**BOARD OF ZONING ADJUSTMENT  
STAFF REPORT****Date: May 4, 2015**

<b><u>CASE NUMBER</u></b>	5965
<b><u>APPLICANT NAME</u></b>	Mikell & Claire Taylor
<b><u>LOCATION</u></b>	4550 Knight Way Drive (West side of Knight Way Drive, 100'+ East of Kings Way Drive)
<b><u>VARIANCE REQUEST</u></b>	<b>BUILDING SETBACK:</b> Side Yard Setback Variance to allow the construction of a garage within 5 feet of the side yard setback in an R-1, Single-Family Residential District.
<b><u>ZONING ORDINANCE REQUIREMENT</u></b>	<b>BUILDING SETBACK:</b> The Zoning Ordinance requires all structures to be a minimum of 8' from the side yard property line in an R-1, Single-Family Residential.
<b><u>ZONING</u></b>	R-1, Single-Family Residential District
<b><u>AREA OF PROPERTY</u></b>	0.45±Acres
<b><u>CITY COUNCIL DISTRICT</u></b>	District 5
<b><u>ENGINEERING COMMENTS</u></b>	If the variance is approved, the applicant will be required to receive an approved land disturbance permit prior to beginning any site work.

# SITE PLAN

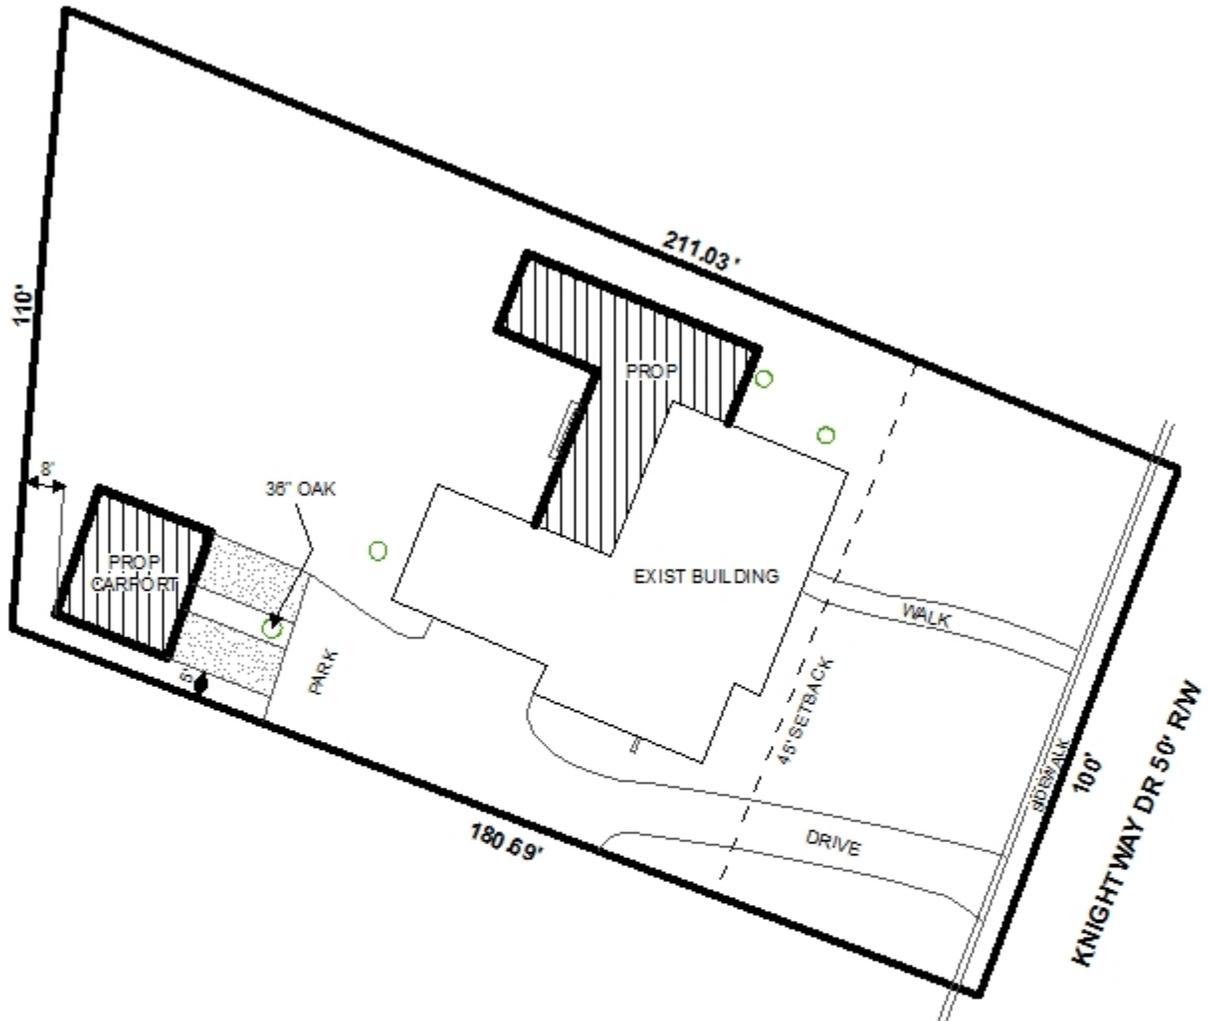
As stated, the applicants wish to construct a new, two-car carport in the rear of their residence. Due to the applicants desire to preserve a 36" live oak tree, they are requesting that the freestanding carport be built 5'-0" from the side yard property line in lieu of the minimum 8'-0" distance required by the Zoning Ordinance. In addition to preserving the live oak tree, the applicants also stated that the 5'-0" side yard setback will provide unobstructed access to the two bays of the proposed carport. Upon reviewing the site, it appears that there is an existing two-car carport attached to the residence. The applicants have indicated that there will be alterations made to the existing carport, but have not made any mention of its intended future use. It does appear, however, that there are plans to expand the footprint of the house and make extensive internal changes. Information is needed regarding the future use of the existing carport.

In reviewing the applicant's request for variance as submitted, there does not appear to be any special conditions which exist such that a literal enforcement of the Ordinance will result in an unnecessary hardship.

The presence of two large live oaks in the driveway area do, perhaps, present a hardship regarding the extension of the driveway and the construction of a carport. Adding additional paving and a structure around the existing tree, as proposed, will not ensure the longevity of the tree due to possible impacts to the root system.

Based on the preceding, Staff recommends Holdover to the June 8<sup>th</sup> meeting, with revisions submitted by May 15<sup>th</sup>, so the following can be addressed:

- 1) Additional information regarding the use of the existing carport; and
- 2) Additional Information supporting that there is no other viable location in the rear yard.
